Design Review Comment Form

Rose Quarter
August 1, 2001

TRANSIT INTENSIVE OPTION

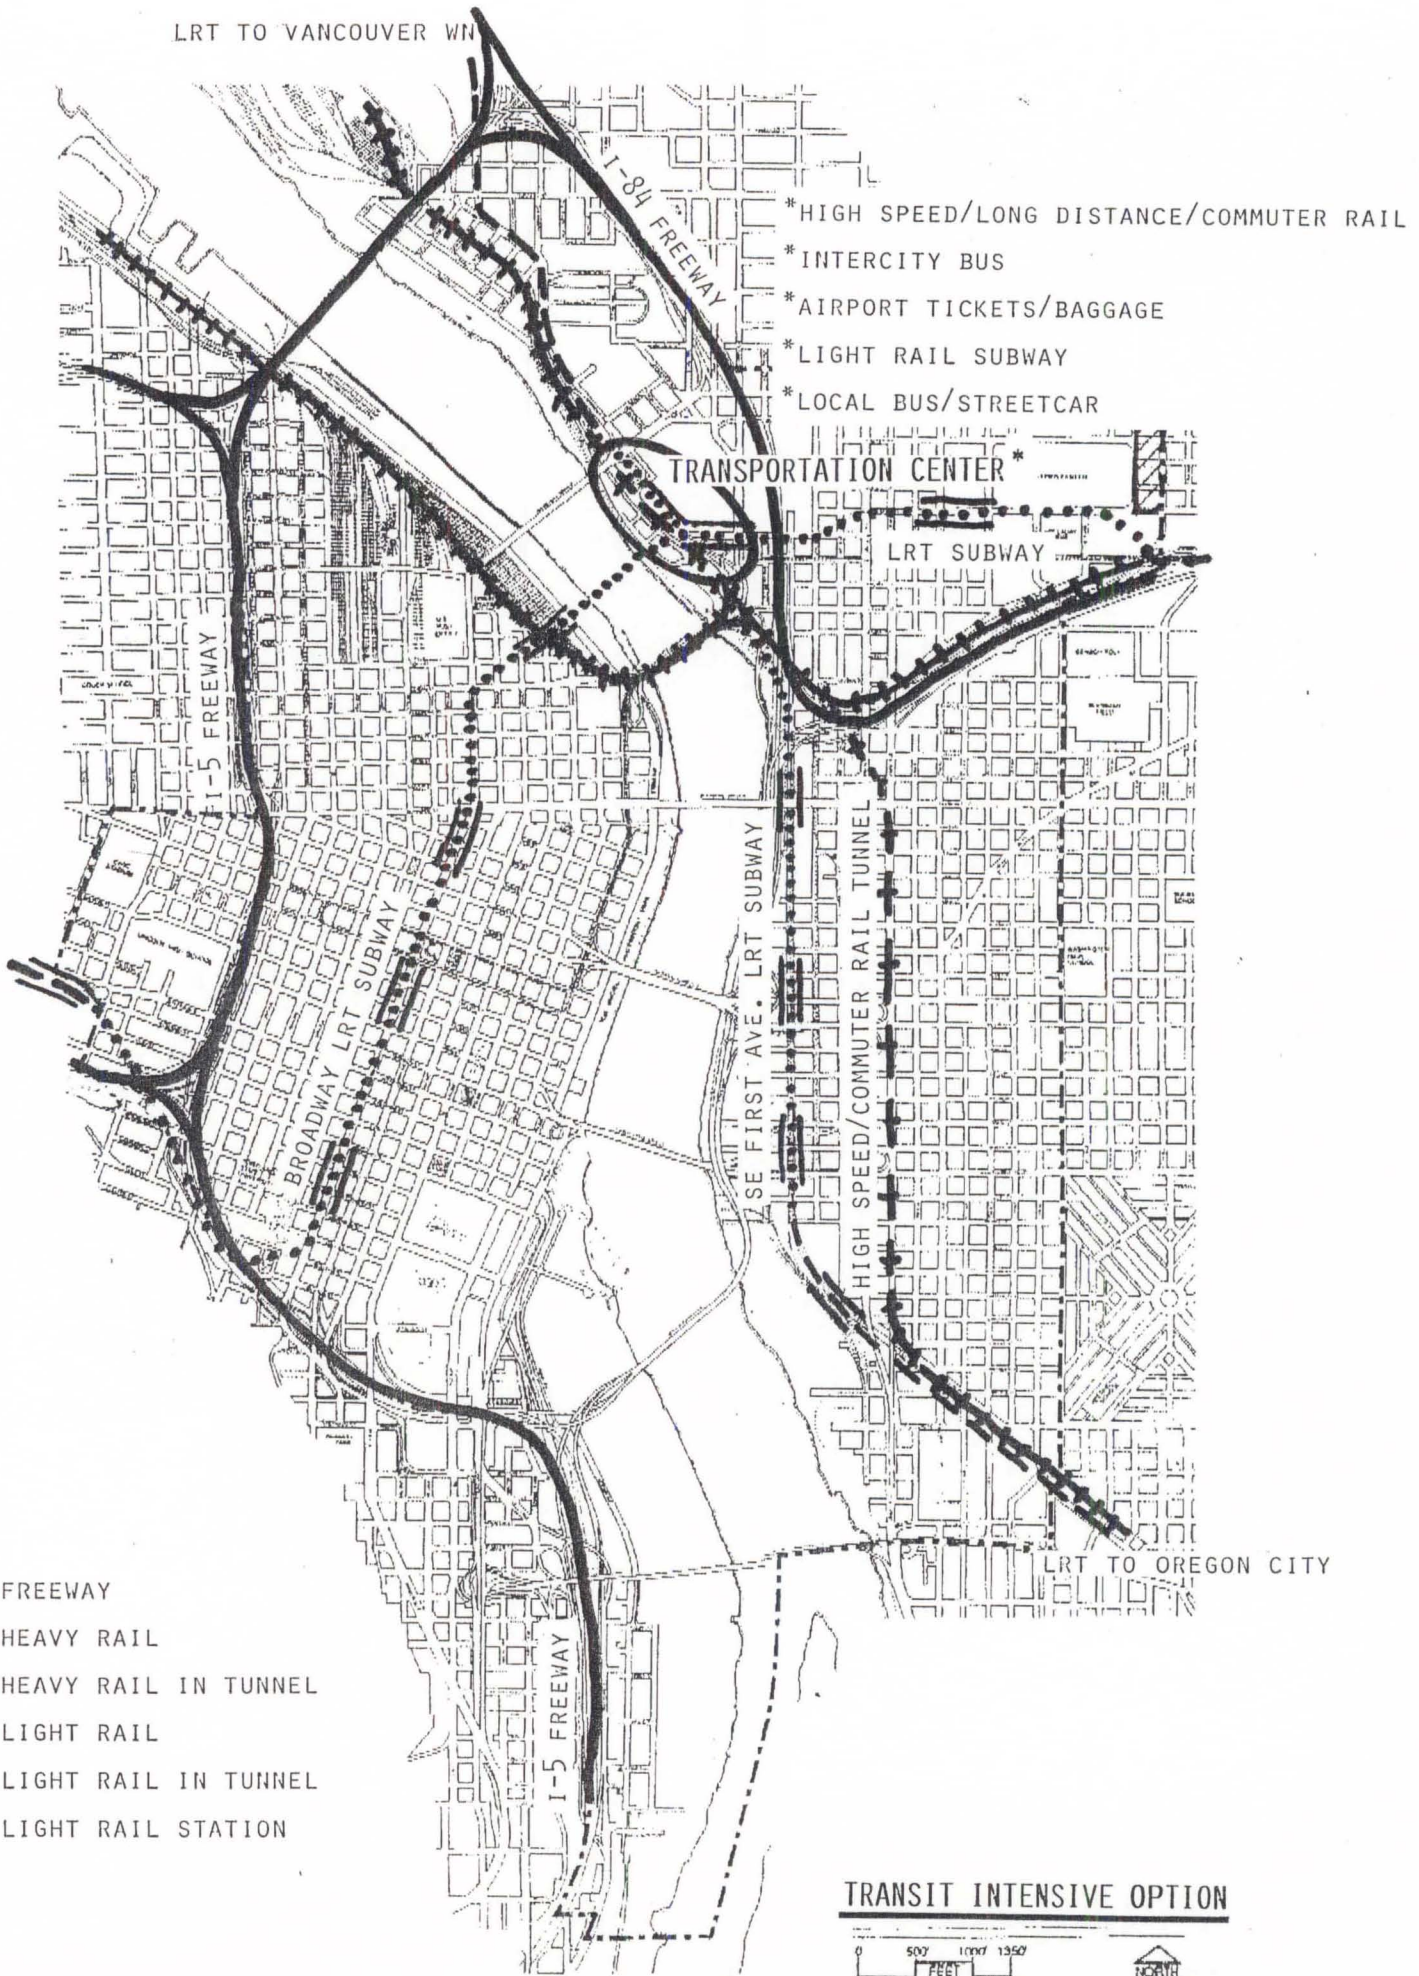
FREEWAY STREAM-LINING

HOW TO REMOVE I-5 FROM THE EAST BANK AND CONVERT I-405 TO I-5

- REMOVE KIRBY ST. RAMPS AND DIVERT THIS LANE TO I-84
- REMOVE EXISTING RAMP FROM FREMONT BRIDGE TO I-5 SOUTH
- WIDEN (FROM 2 TO 3 LANES) FREMONT BRIDGE RAMPS TO/FROM I-5 NORTH
- REMOVE I-405 ON RAMPS FROM 5TH, 6TH, MONTGOMERY, TAYLOR AND 14TH STREETS
- REMOVE I-405 OFF RAMPS TO 6TH, SALMON AND COUCH STREETS.
- WIDEN I-405 FROM 2 TO 3 LANES EACH WAY AND DESIGNATE IT I-5
